Urgent Field Safety Notice

Software upgrade on a dialysis machine

NIPRO CORPORATION

- **FSCA number:** FSCA 2021/07/30
 - **Product:** Surdial X
 - **Type of action:** Software update
-

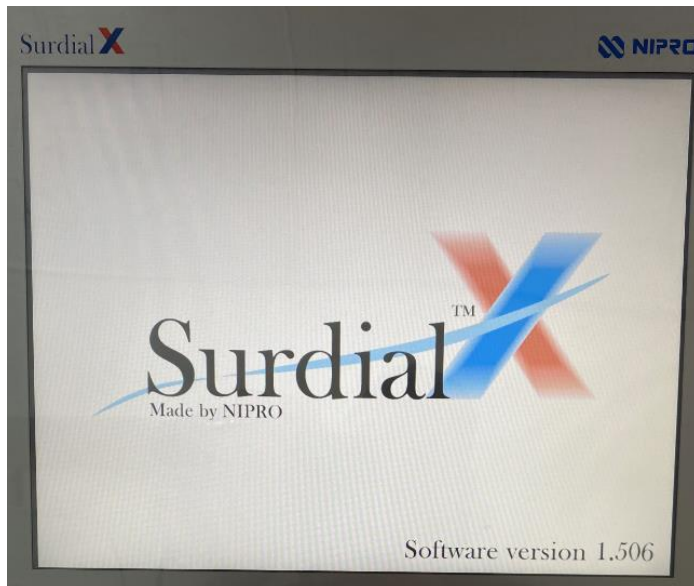
The Software 1.485 or higher has an additional sequence within the start-up test to verify the performance of the UFP. Therefore, devices operating with lower software versions should be updated to version 1.485 or higher to ensure the correct operation of the device and to mitigate potential risks.

At machine start-up, the model name and Software version are displayed.

The software is available from Nipro Medical Europe. Our technical service team will contact you to support the update.
